**Agenda**  
**Village of Homer Glen**  
**COMMITTEE OF THE WHOLE**  
**Wednesday, January 14, 2026- 5:30p.m.**  
**Village Board Room, 14240 W. 151<sup>st</sup> Street, Homer Glen**

**Agenda Item Number:** E  
**Committee of the Whole Date:** January 14, 2026  
**Subject:** Case# HG-2518-SPPUD  
ComEd Substation  
**Address:** 13015 W. 143<sup>rd</sup> Street

**Item Title:** **ComEd Substation Improvements (Workshop):** Future request for a Special Use Permit for a Planned Unit Development (PUD), with certain exceptions, and Site Improvement Plans for certain real property located at 13015 W. 143<sup>rd</sup> Street, Homer Glen, Illinois [HG-2518-SPPUD].

ASK-02  
Project: ComEd Goodings Grove  
Description: Elevations - East and West  
Prepared by: ZVS  
Scale: 1:200

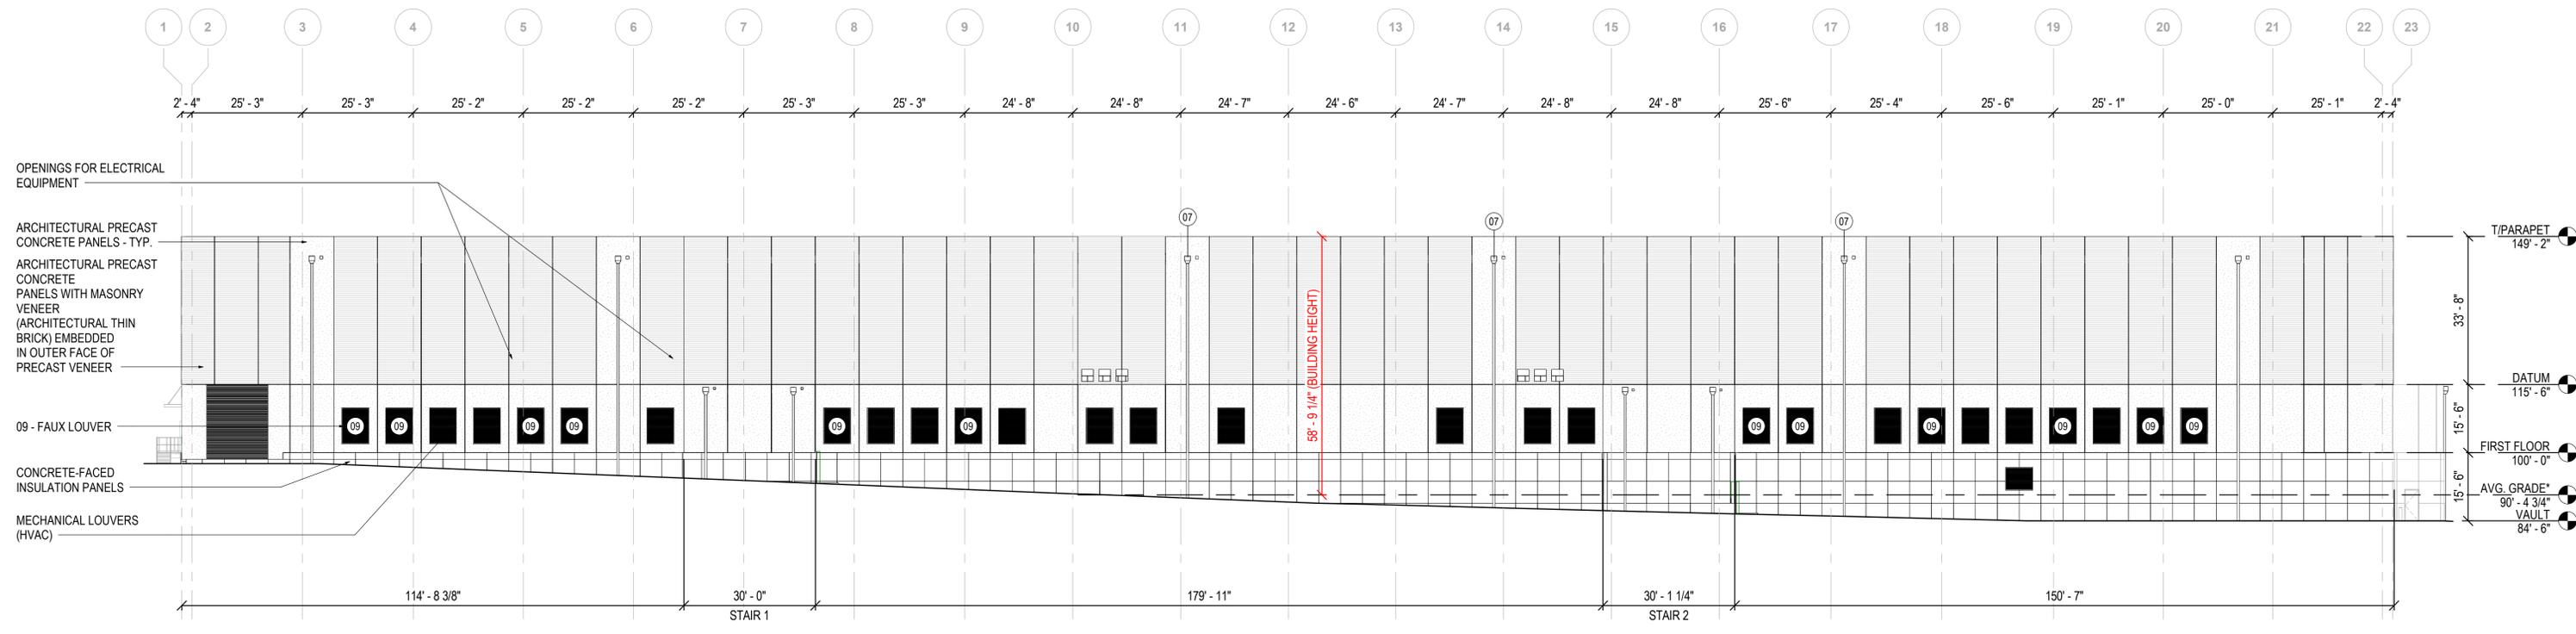
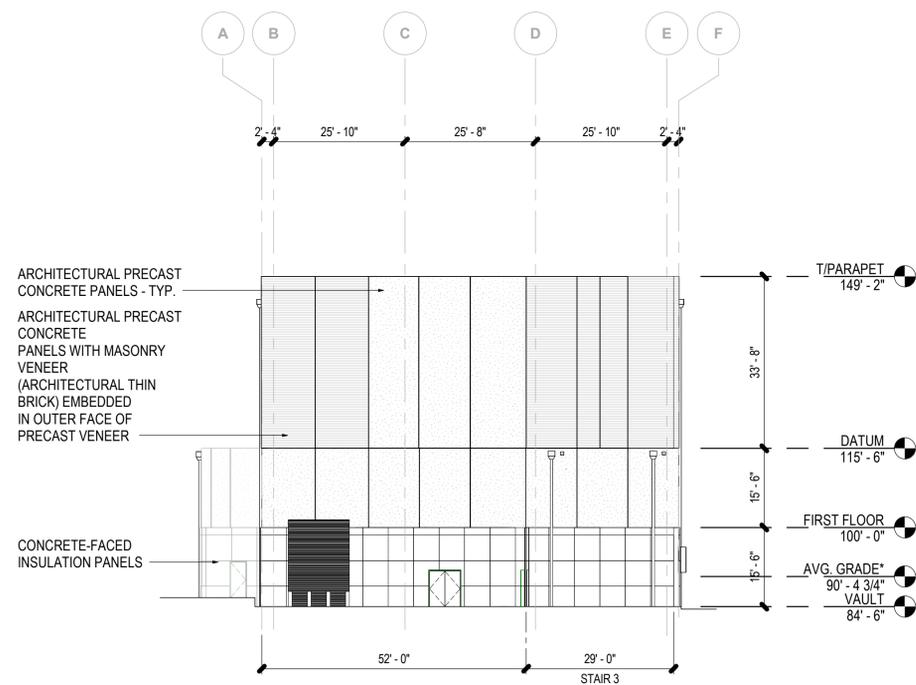
**Exterior Construction Standards (Chapter 75, Article II):** The exterior construction standards **do apply** to this request. The building would be constructed of architectural precast concrete panels with masonry veneer (thin brick). The masonry veneer (thin brick) is generally accepted to have a more “enhanced” appearance than precast concrete panels. Most of the thin brick would be used on the front and sides of the building, with much less on the rear of the building facing west.

**2 CITY RESPONSES - FIRST FLOOR PLAN**  
SCALE: 1:200

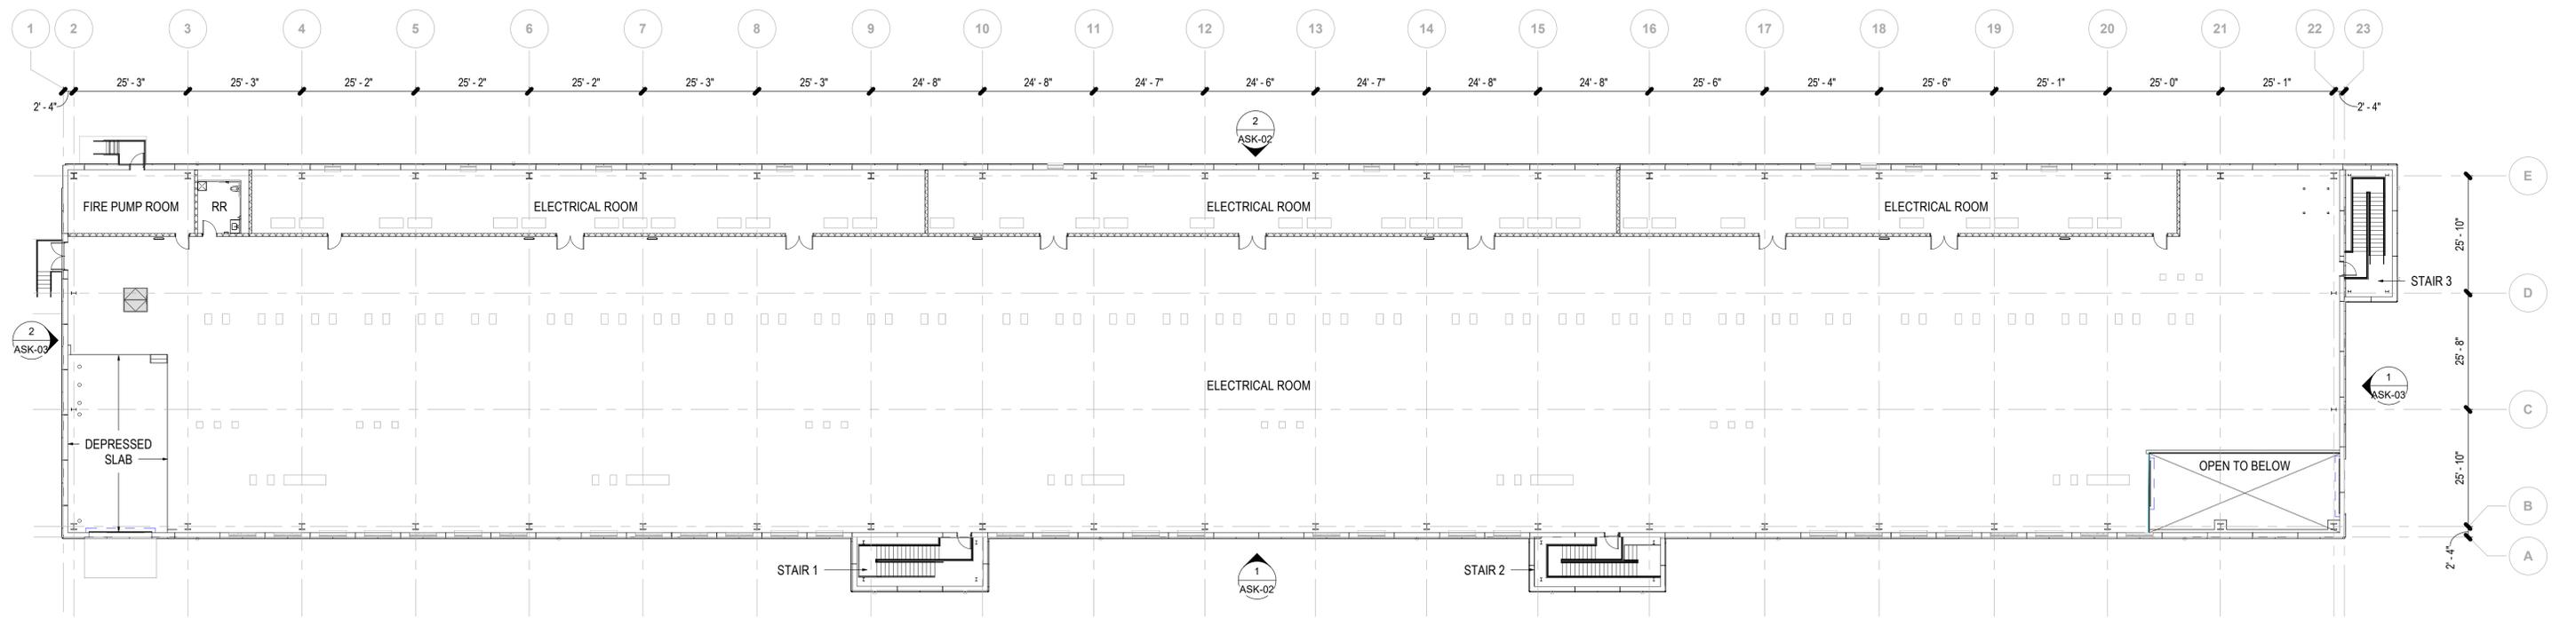
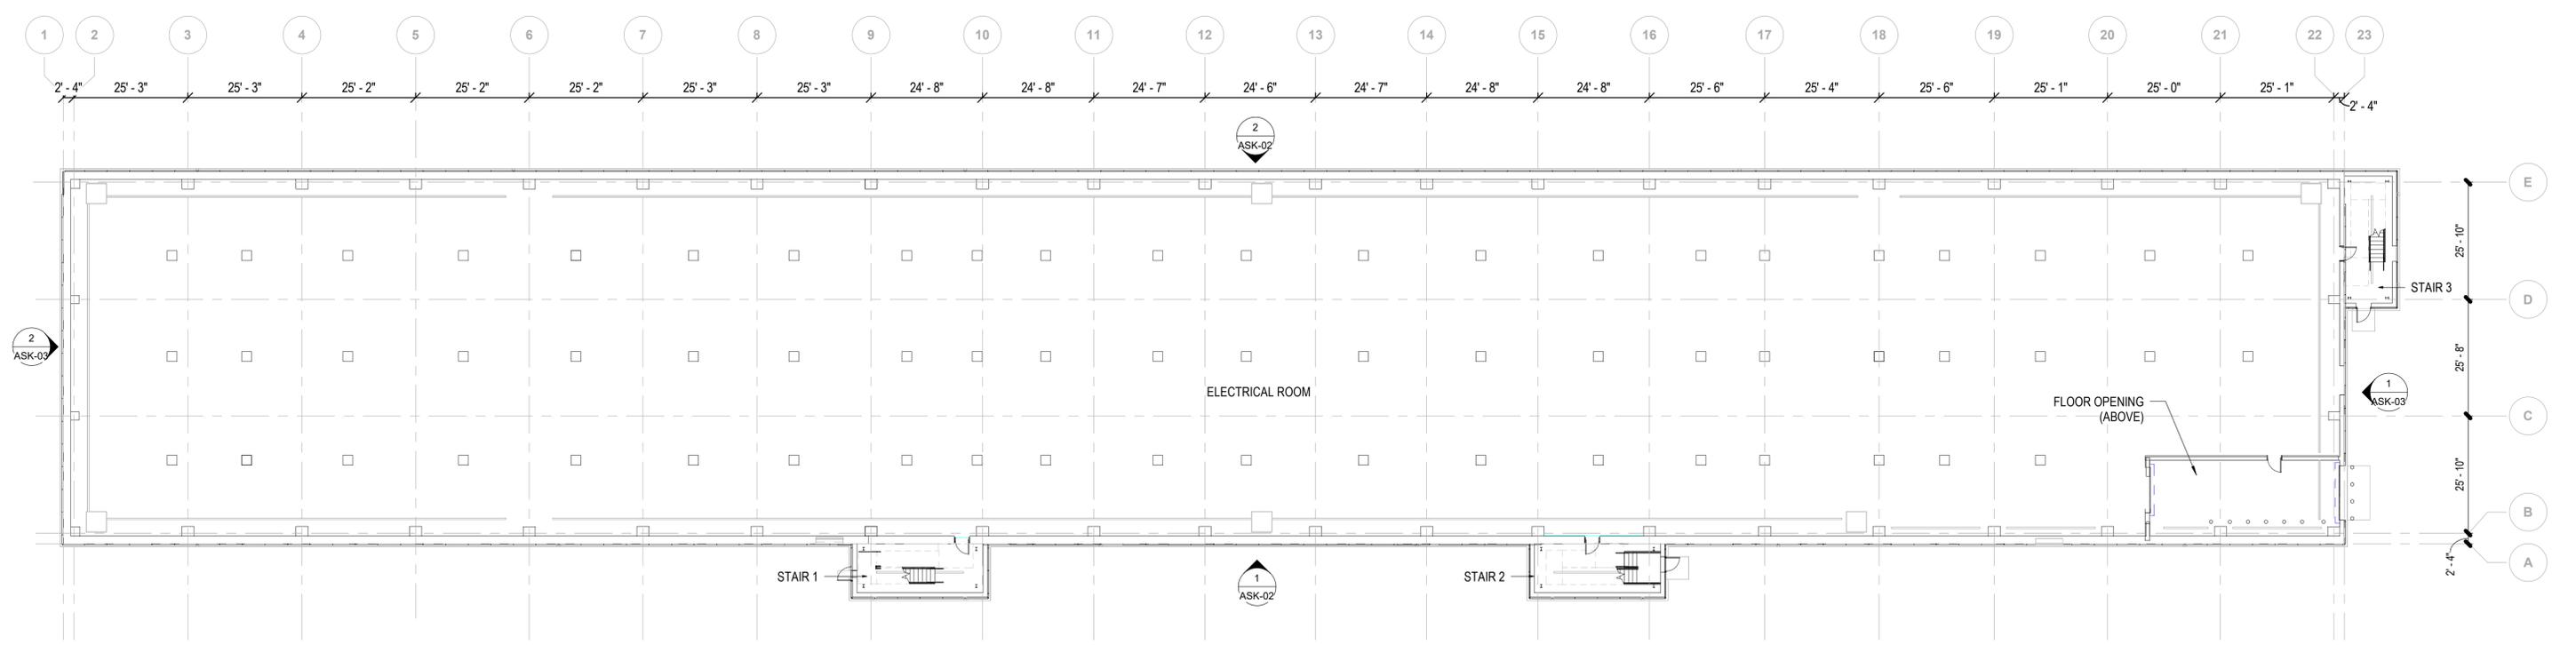
The proposed primary building would measure approximately 82' wide by 513' long. The Floor Plan submitted by the applicant illustrates that this building would contain two floors. The "Vault Plan" is essentially the lowest floor and functions like a walk-out basement. The first floor sits above the Vault Plan. The footprint of this building is approximately 42,470 square feet. With two floors, the approximate gross floor area is 84,940 square feet. This building was designed to allow for increased capacity over time. A bathroom would be located within this building.
